Drawing Change Notice

CHANGE DOCUMENT NO.
24590-PTF-VDCN-MS-10-00009

JOB NO.	TITLE FOR CHANGE NOTICE
24590	UFP-VSL-00062C Redesign

Based on the re-analysis of UFP-VSL-00062C, per calculation 24590-PTF-MVC-UFP-00023, for revised seismic conditions and design evolution, required a redesign of the vessel.

SECTION C-C
SCALE: 1/16

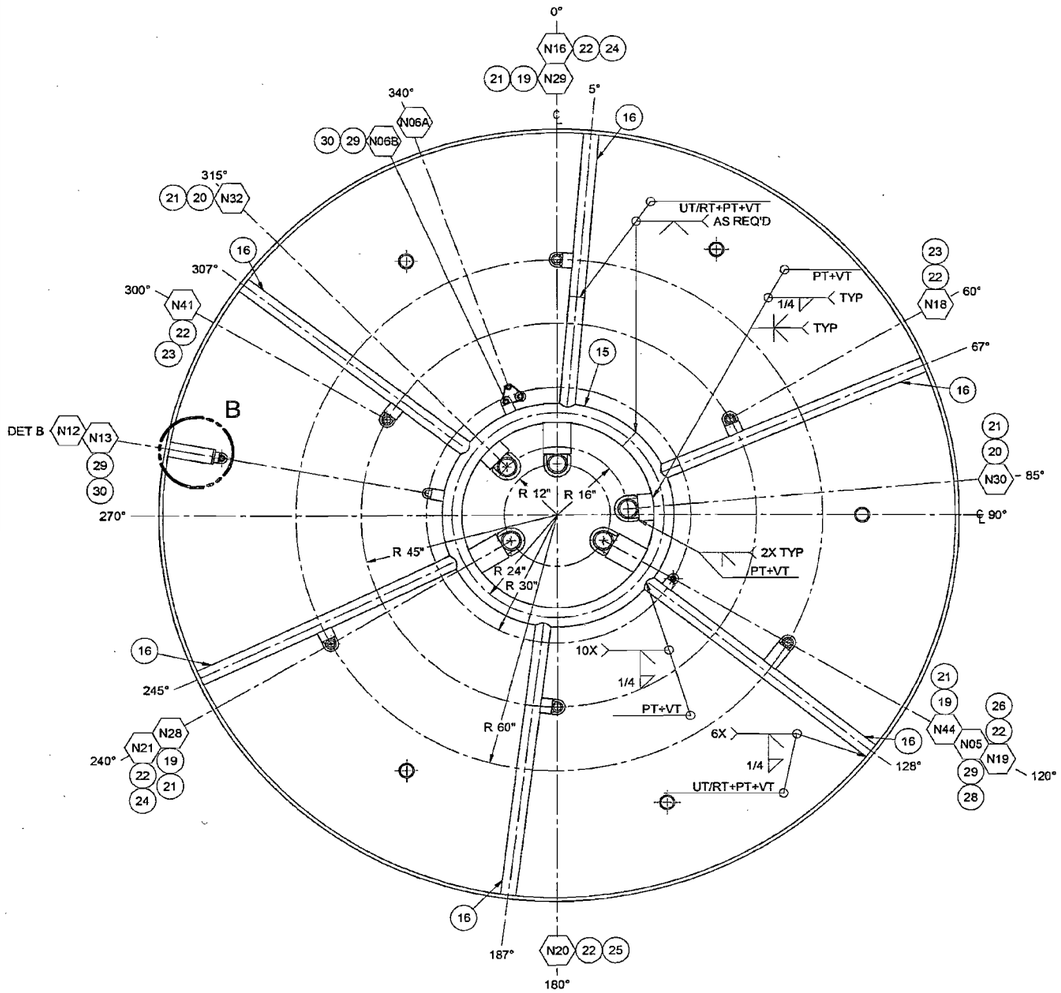
(1.) SECTION C-C

DETAIL-B
SCALE: 1/4

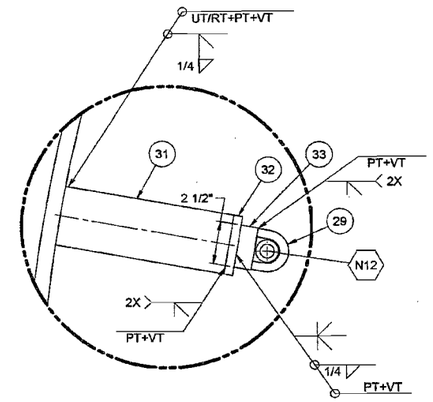
(2.) DETAIL-B

SECTION D-D
SCALE: 1/16

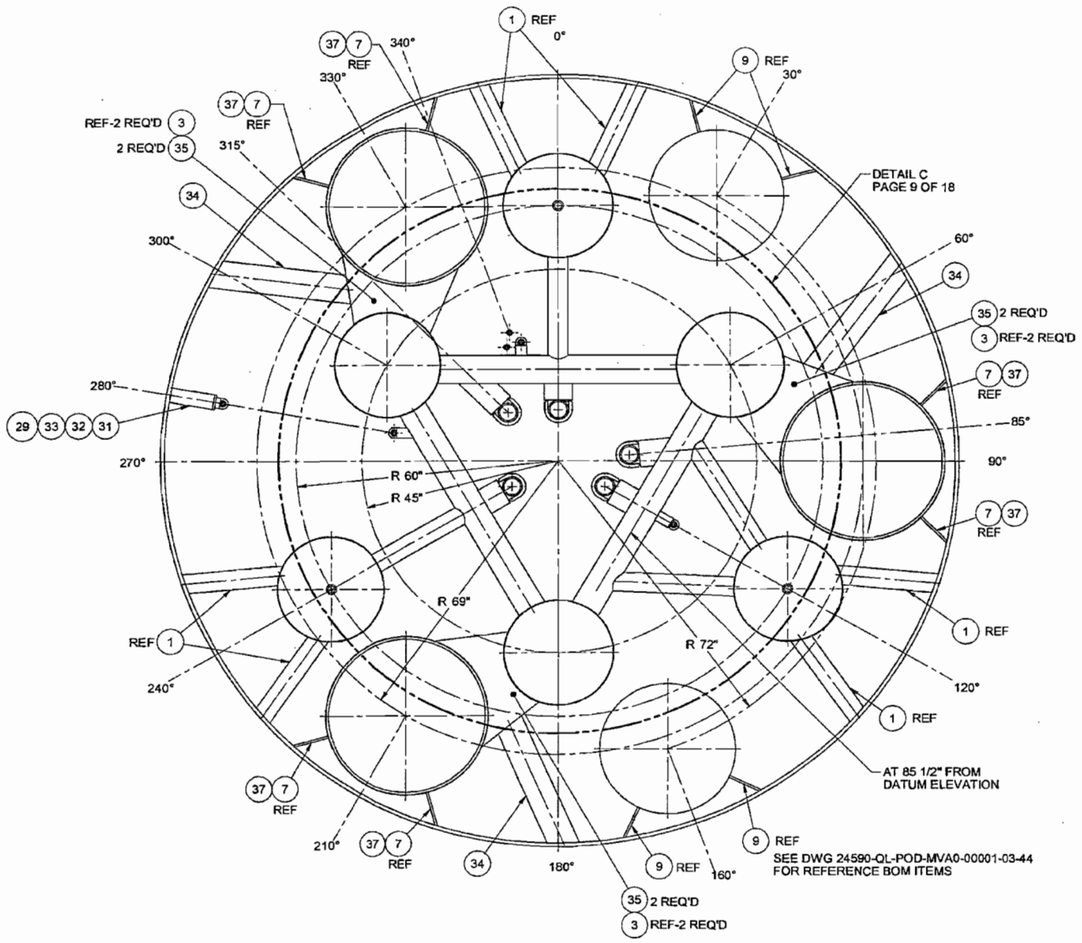
j.) Add SECTION D-D shown on Attachment 1, page 8 of this VDCN.

SECTION E-E
SCALE: 1/16

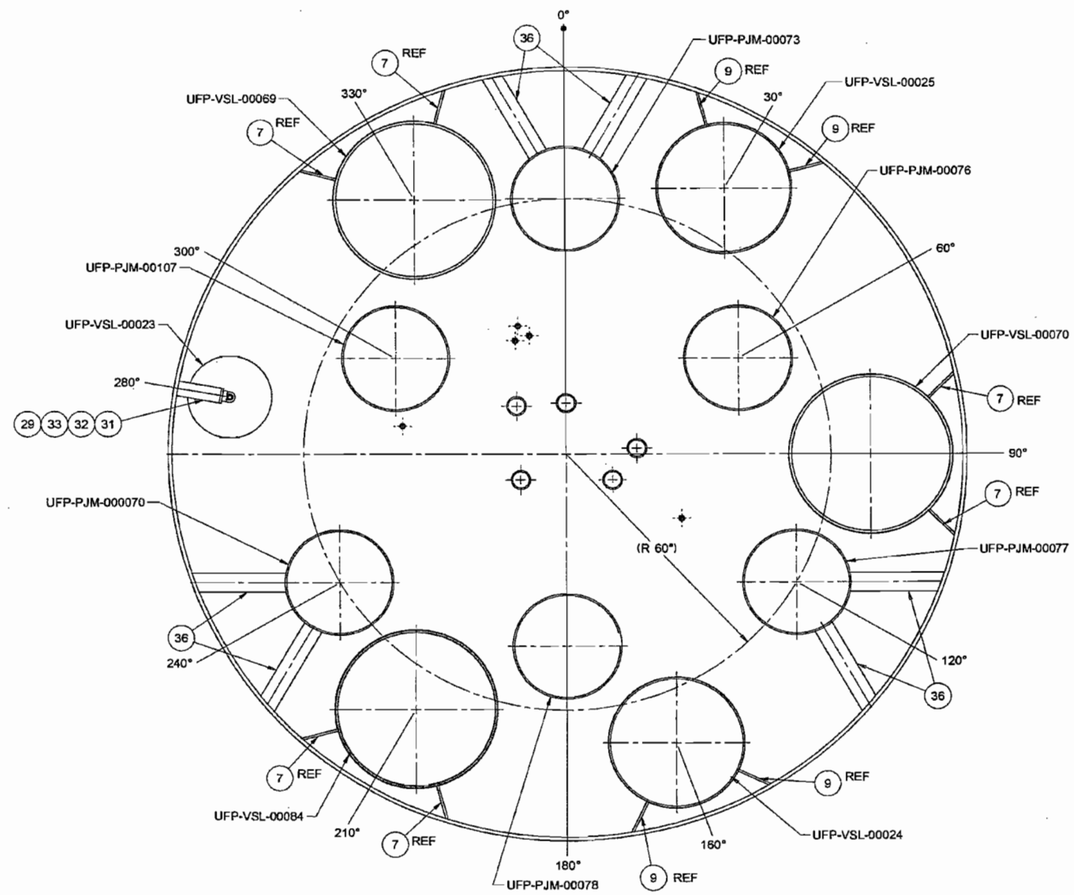
k.) Add SECTION E-E shown on Attachment 1, page 8 of this VDCN.

DETAIL-C
SCALE: 1/8

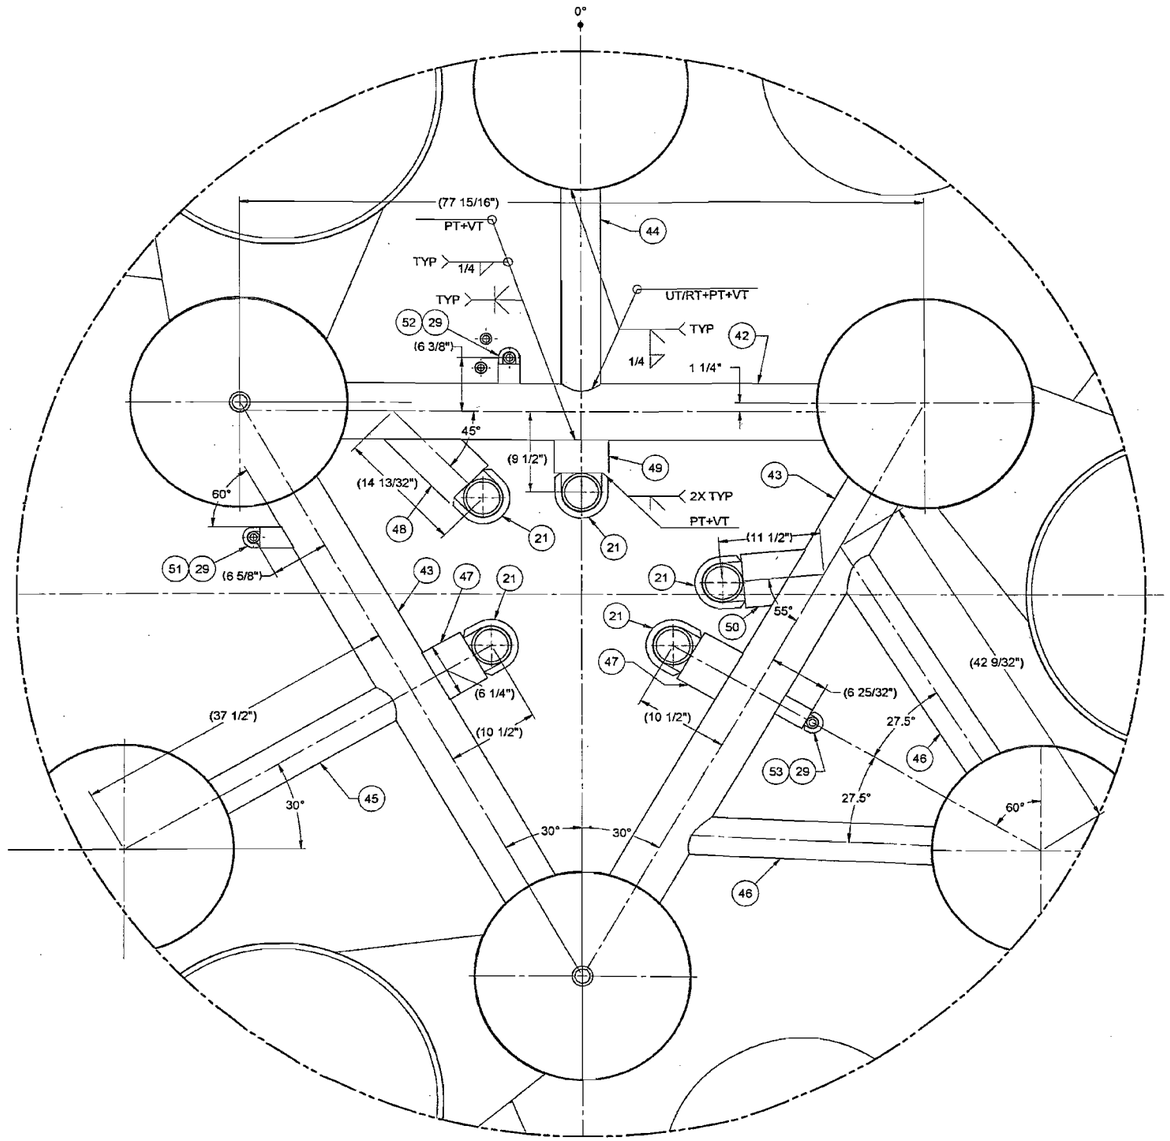
l.) Add Detail C shown on Attachment 1, page 9 of this VDCN.

2" SCH 80 NOZZLE W/ INT. PROJECTION
SCALE: 3/4" = 1"
~~N07~~ ~~N09~~ ~~N10~~ N11 N14 2 3

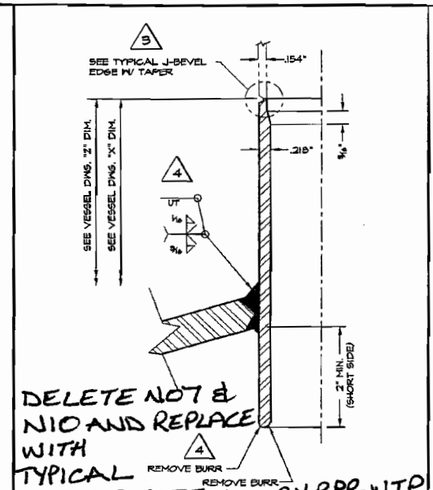
b.) 2" SCH 80 NOZZLE W / INT PROJECTION: Delete N07 and N10 and replace with Typical 160 SCH Detail.

DELETE N07 & N10 AND REPLACE WITH TYPICAL SCH160 DETAIL, BY RPP-WTP

2 / - TYP. LOWER SUPPORT FOR DIP TUBES
NO SCALE

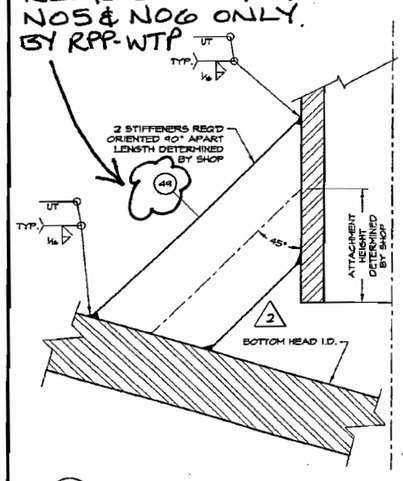
a.) Typ Lower Support For Dip Tubes: Remove support item 49 for N05 and N06 only.
NOTE: This support detail is covered on Vendor drawing 24590-QL-POD-MVA0-00001-03-12 as reflected in item 5 of this VDCN.

REMOVE ITEM 49 FOR N05 & N06 ONLY. BY RPP-WTP

SECTION F-F
SCALE: 1/16

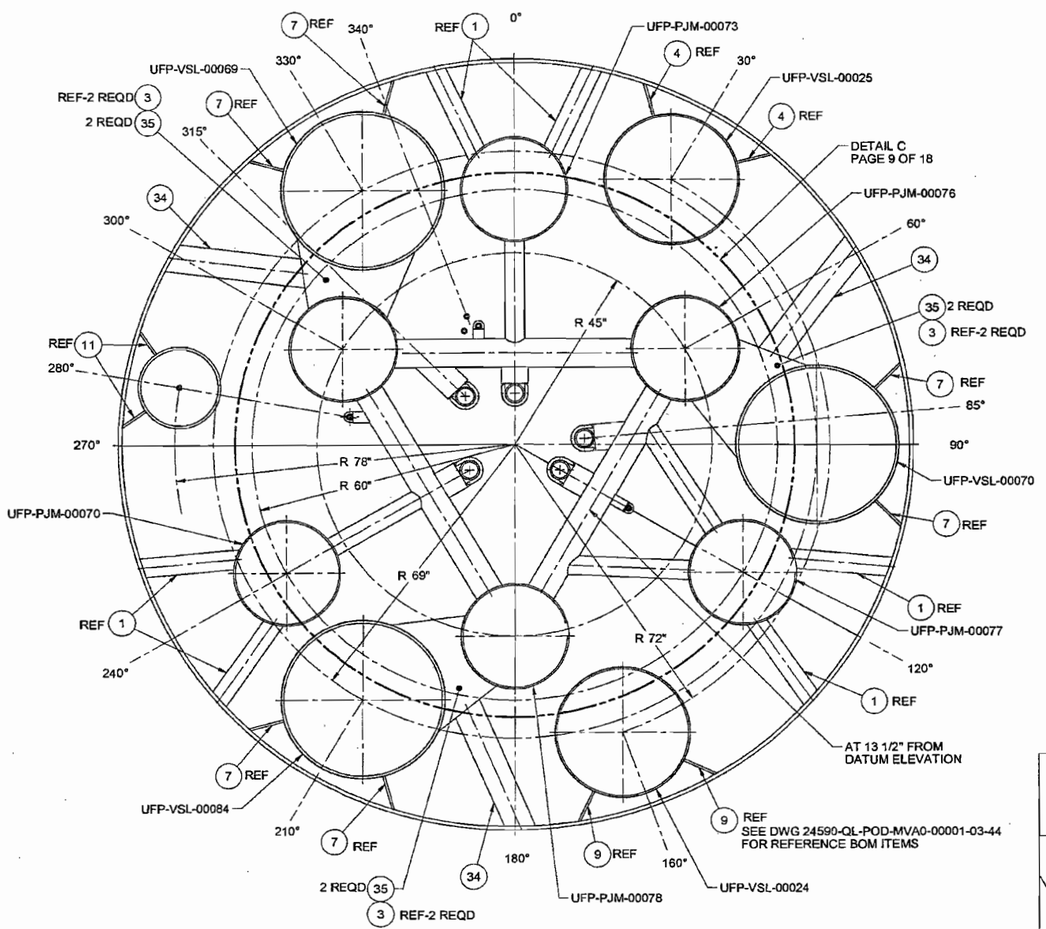
m.) Add SECTION F-F shown on Attachment 1, page 12 of this VDCN.

SECTION G-G
SCALE: 1/16

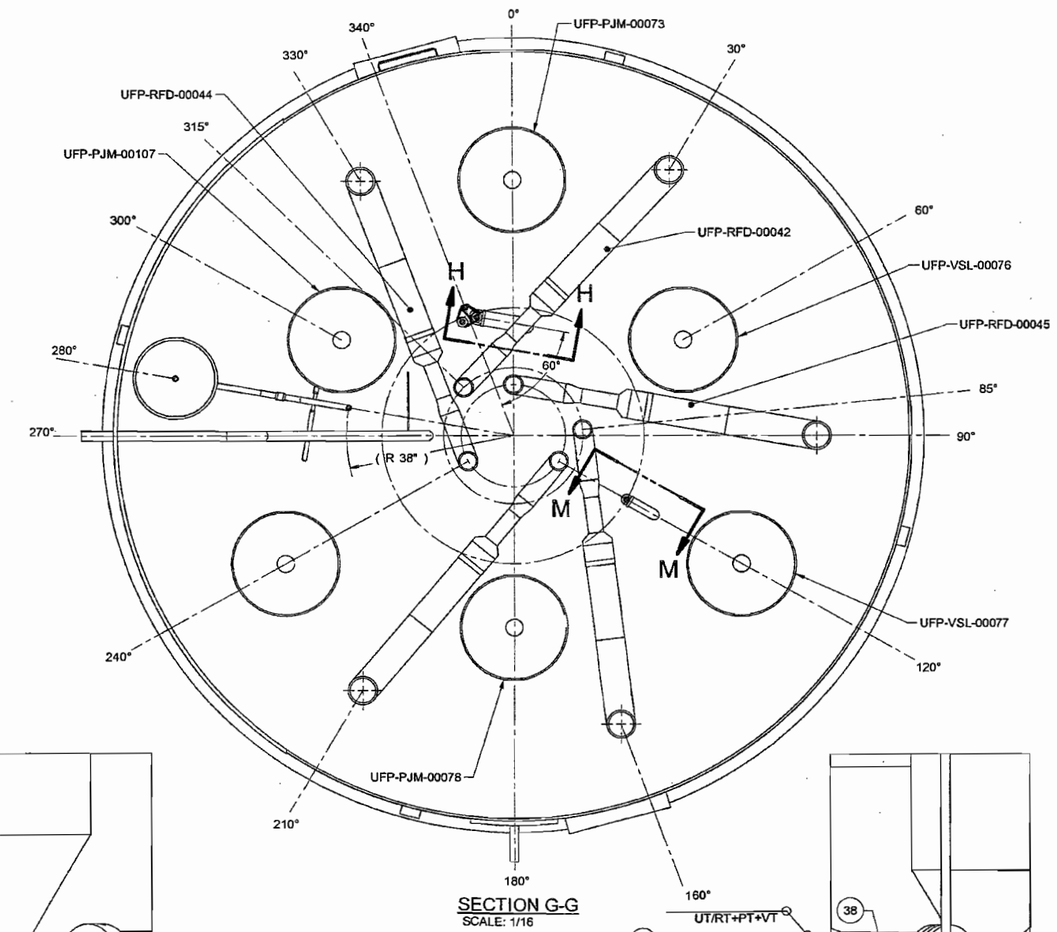
n.) Add SECTION G-G shown on Attachment 1, page 12 of this VDCN.

SECTION H-H
SCALE: 1/10

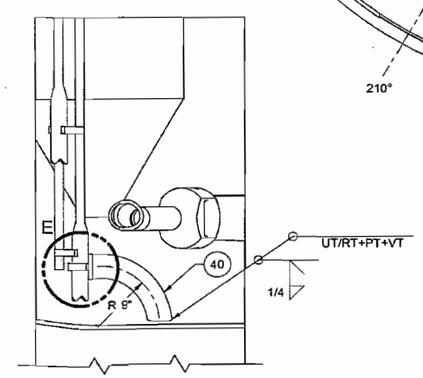
a.) Instrument Assy Detail: Remove support item 49 and replace with items 22, 40, and 41, shown by SECTION H-H and DETAIL-E, Attachment 1, page 12 of this VDCN.

DETAIL-D
SCALE: 1/5

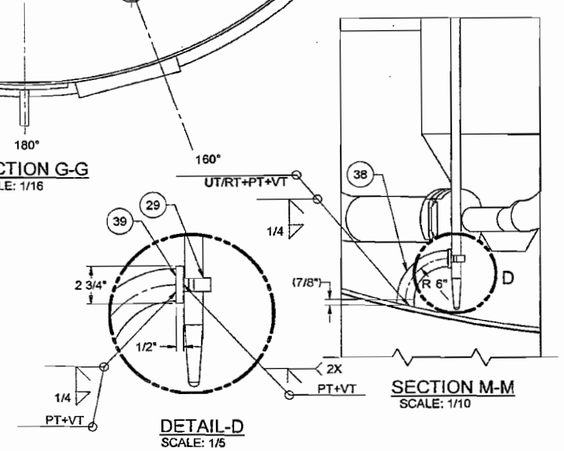
b.) Thermowell Assembly: Remove support item 49 and replace with items 29, 38, and 39, shown by SECTION M-M and DETAIL-D, Attachment 1, page 12 of this VDCN.

TYPICAL OUTER PJM PIPE SUPPORT
SCALE: ½" = 1'-0"

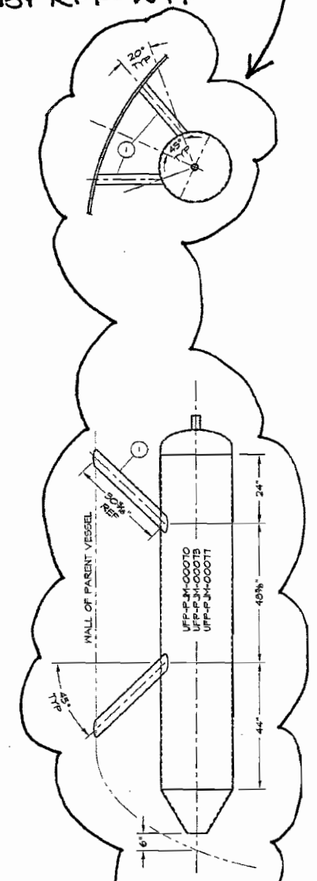
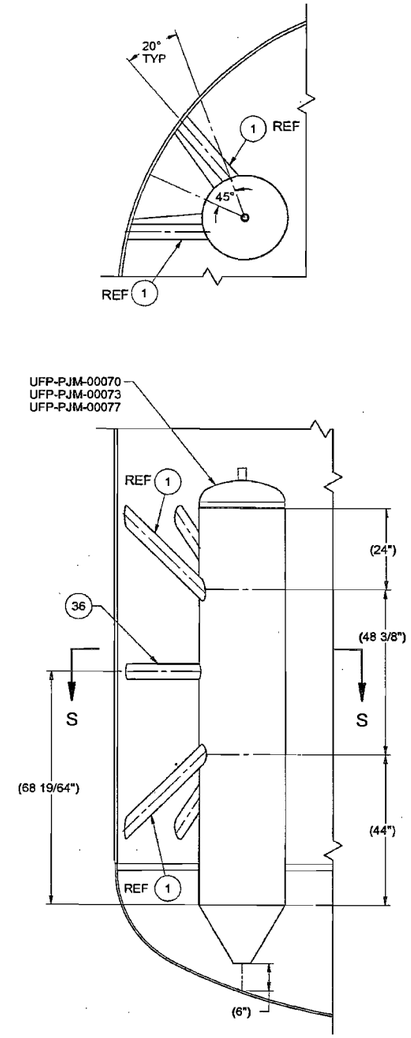
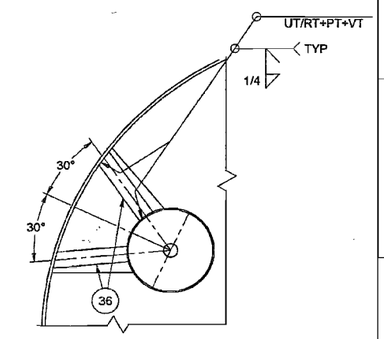
a.) Typical Outer PJM Pipe Support: Delete Typical Outer PJM Pipe Support view and replace with TYPICAL OUTER PJM SUPPORT, SECTION S-S and associated views shown on Attachment 1, page 14 of this VDCN.

DELETE AND REPLACE BY RPP-WTP

36" CHARGE VESSEL & INNER PJM SUPPORT
SCALE: ½" = 1'-0"

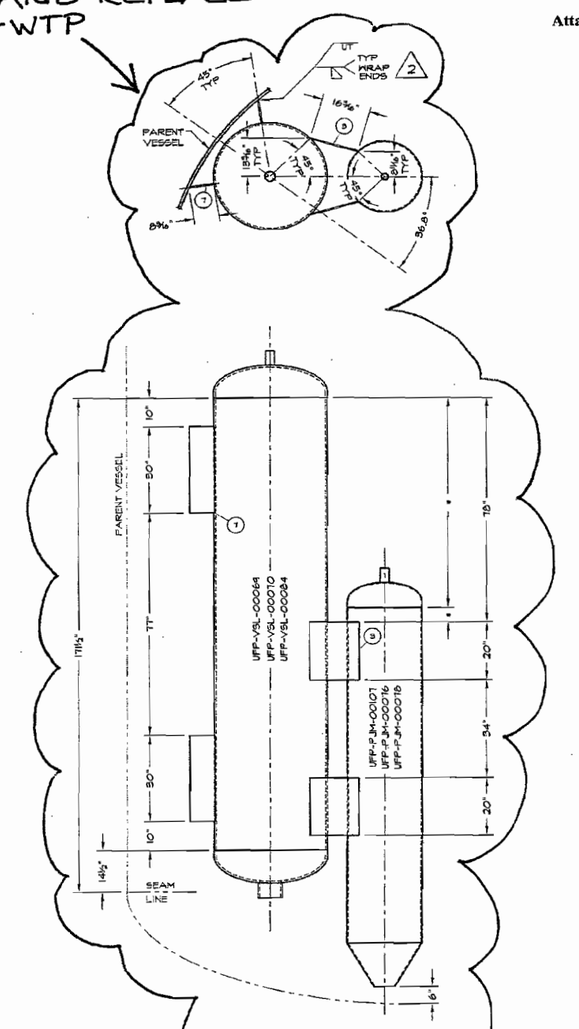
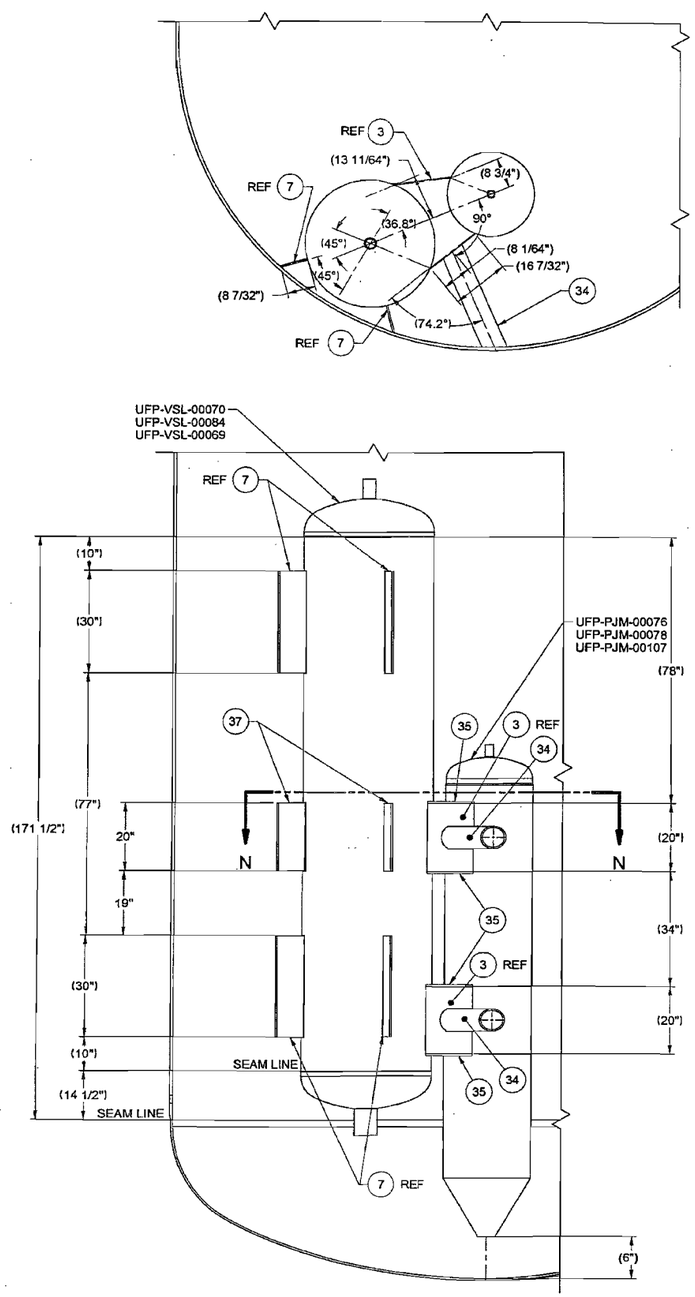
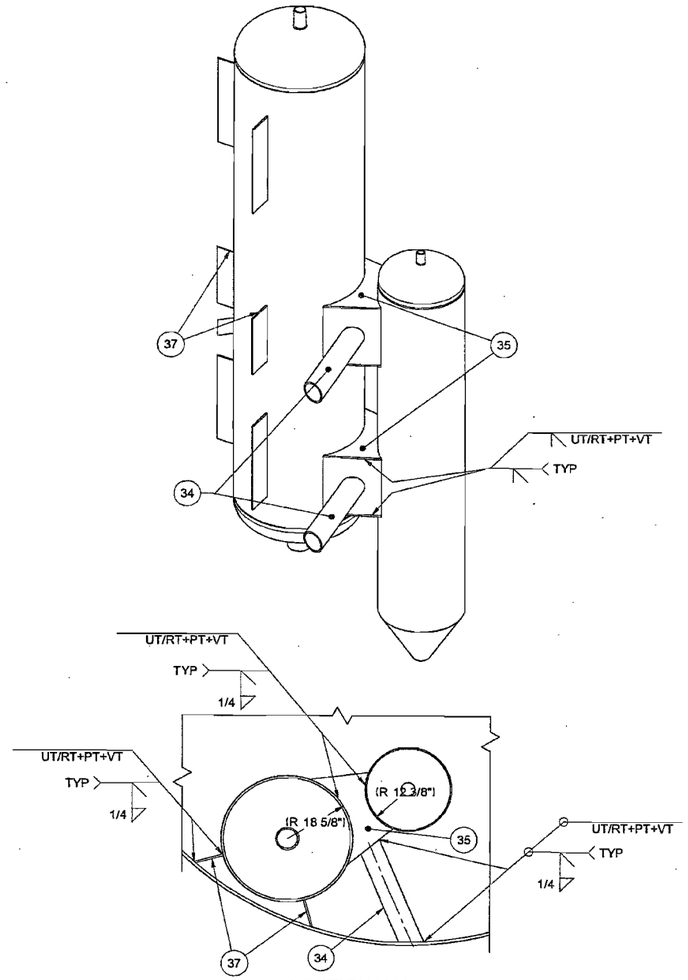
b.) 36" Charge Vessel & Inner PJM Support: Delete 36" Charge Vessel & Inner PJM Support and replace with 36" CHARGE VESSEL & INNER PJM SUPPORT, SECTION N-N, and associated views shown on Attachment 1, page 14 of this VDCN.

DELETE AND REPLACE BY RPP-WTP

36" CV DELIVERY RFD PUMP DETAIL
SCALE: 1" = 1'-0"

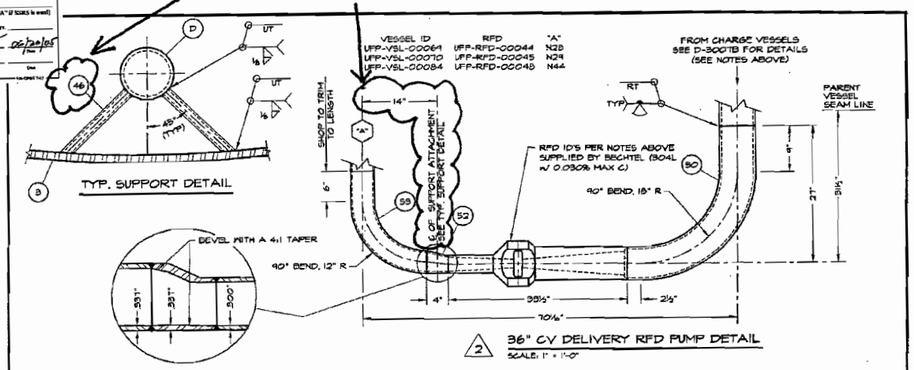
a.) 36" CV Delivery RFD Pump Detail: Remove support item 46 from TYP SUPPORT DETAIL and reference to SEE TYP SUPPORT DETAIL including dimension.

REMOVE BY RPP-WTP

30" CV DELIVERY RFD PUMP DETAIL
SCALE: 1" = 1'-0"

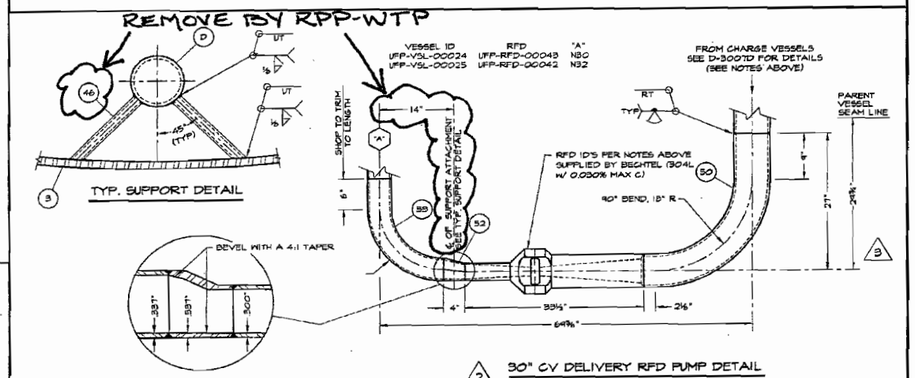
b.) 30" CV Delivery RFD Pump Detail: Remove support item 46 from TYP SUPPORT DETAIL and reference to SEE TYP SUPPORT DETAIL including dimension.

REMOVE BY RPP-WTP
